ADDENDUM

ADDENDUM # 2

Bid 20C3, Carroll Manor Elementary School Window and Door Replacement - Phase II

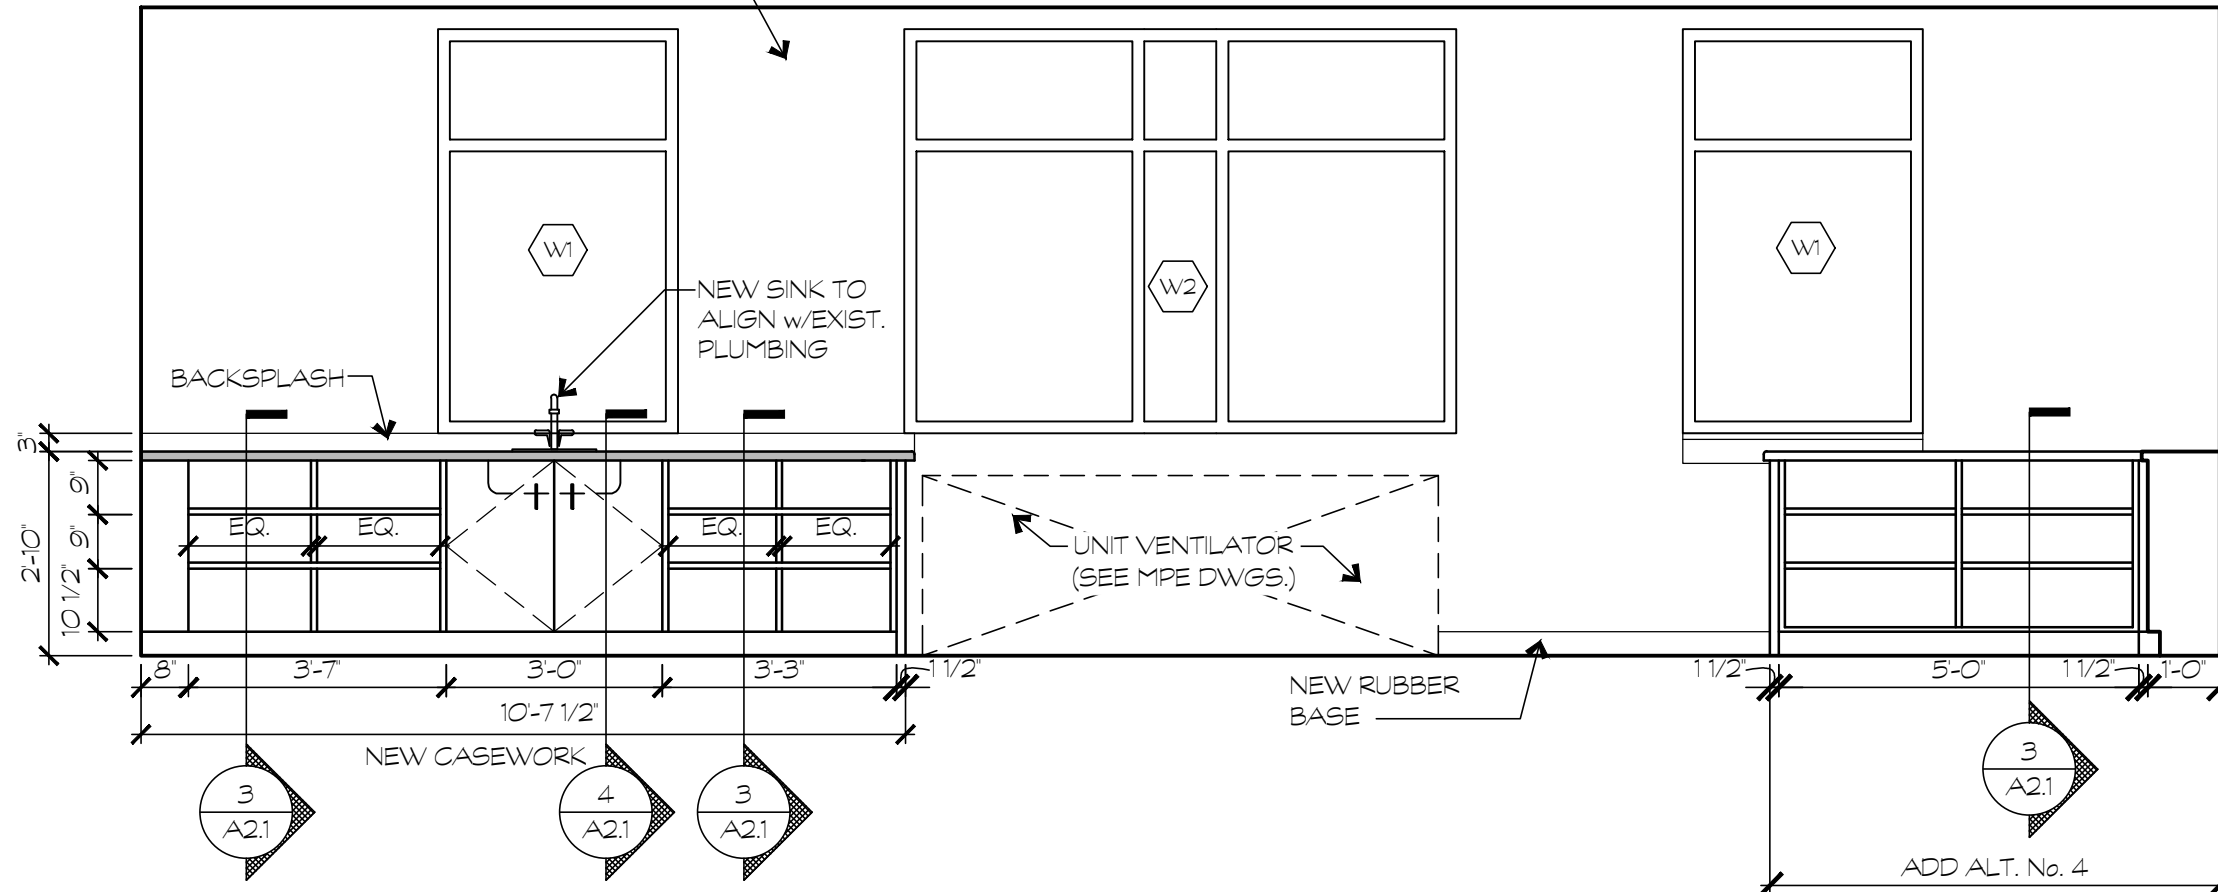
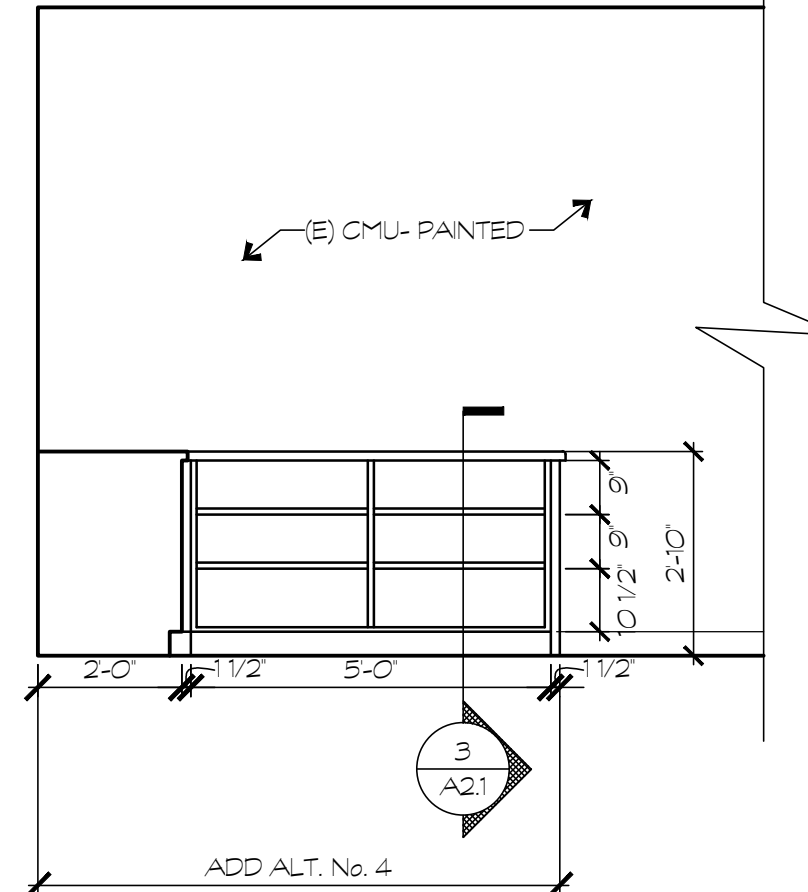
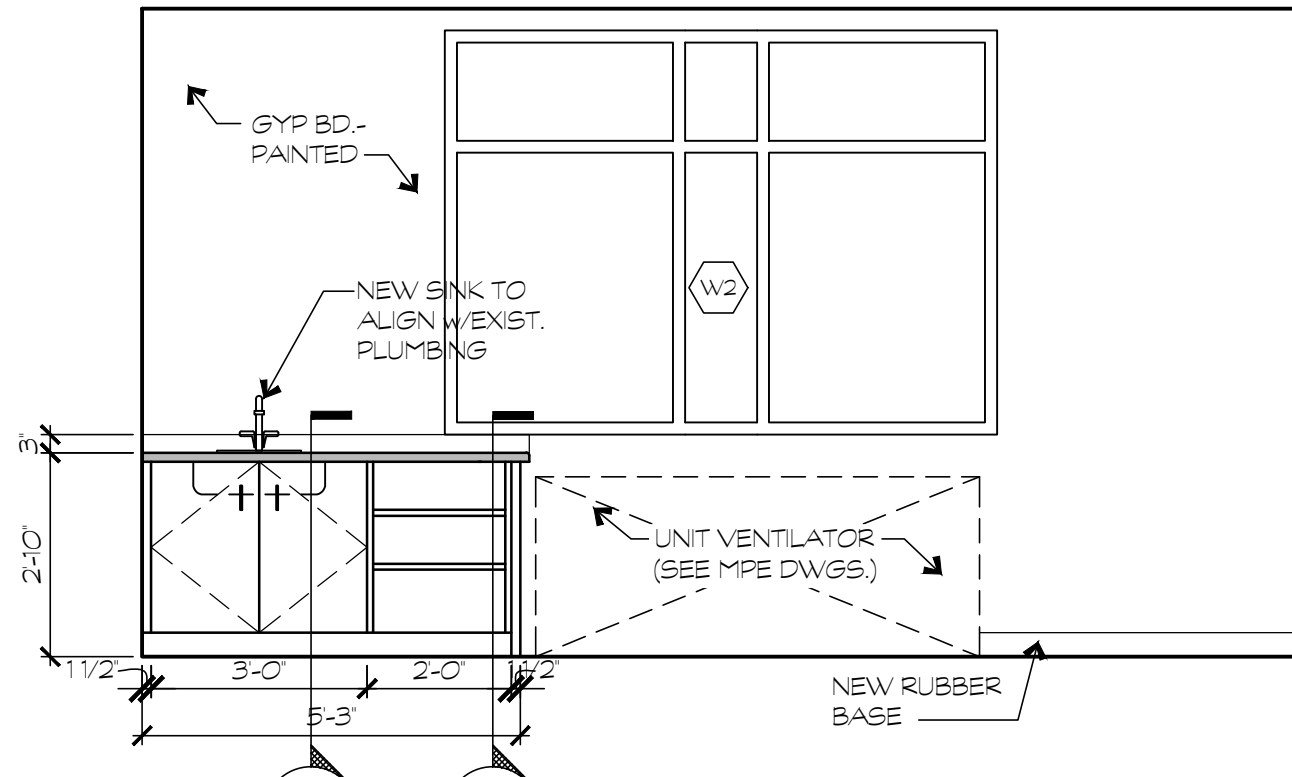
1. Please note the revised due date: ~~Thursday, February 27, 2020~~ **Friday, February 28, 2020**, prior to and time stamped no later than 11:00 A.M.
2. The detail on sheet A2.1 shows window W@ as 10'-9" x 7'-0" which does not match the elevations or floor plan. Please clarify. **Response: Drawing A2.1 Interior Elevations Detail and Schedules; REPLACE drawing A2.1 included in Addendum No. 1 (Tagged with Delta 1) with the attached revised Drawing A2.1 (Delta No.2 dated 2-21-20).**
